PCN-20190111 TE0841-02-* SPI Flash Change

Company	Trenz Electronic GmbH
PCN Number	PCN-20190111
Title	TE0841-02-* SPI Flash Change
Subject	BOM change
Issue Date	2019-07-15

#1 Change SPI Flash from N25Q512A11G1240E to MT25QU512ABB8E12-0SIT

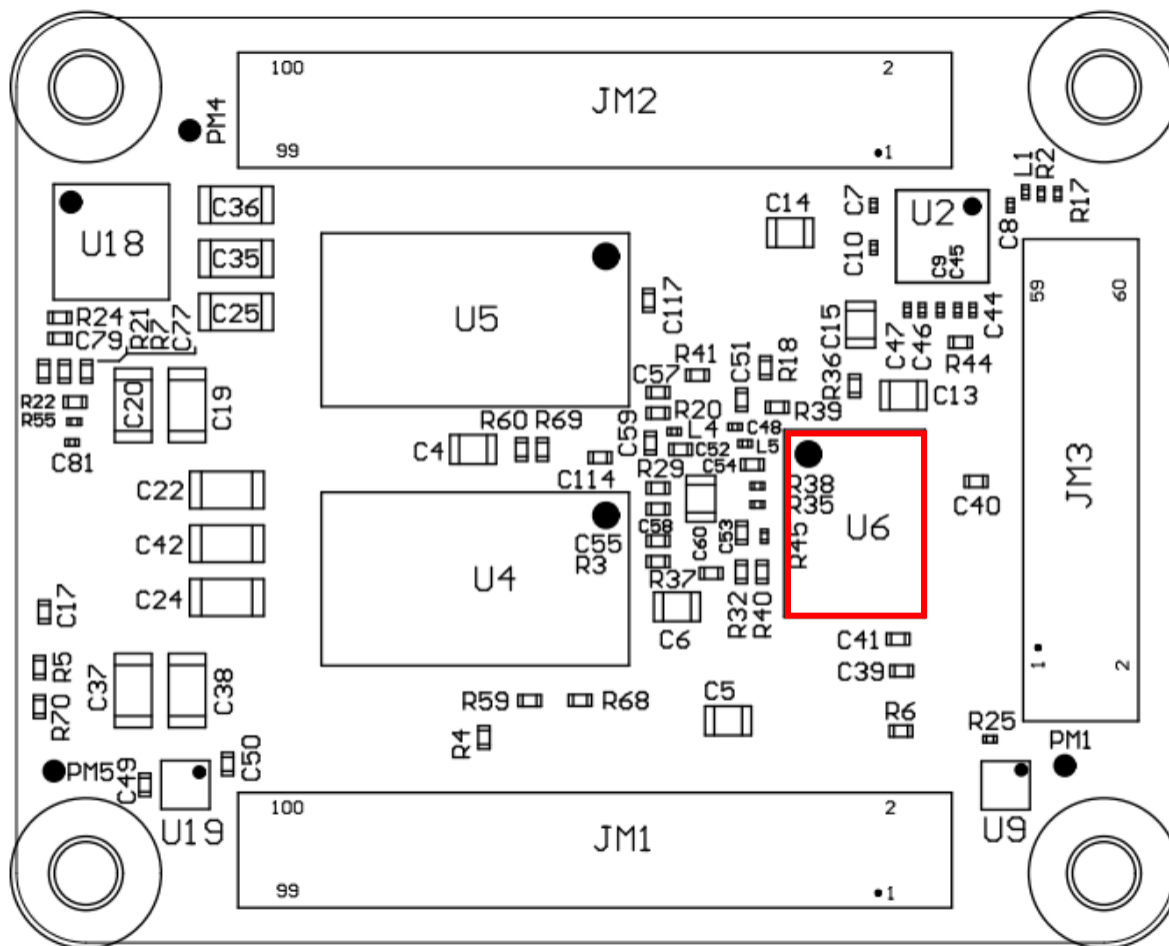
Type: BOM change

Reason: N25Q512A11G1240E became obsolete.

Impact: None. Both have same JEDEC ID BB20h and manufacturer ID 20h.

Locate Flash (U6) on top side of PCB:

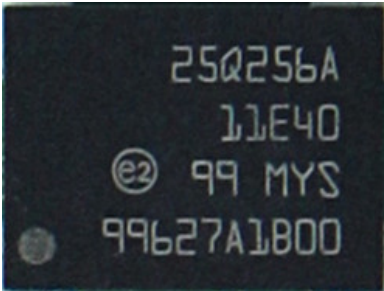
old	new
N25Q512A11G1240E	MT25QU512ABB8E12-0SIT
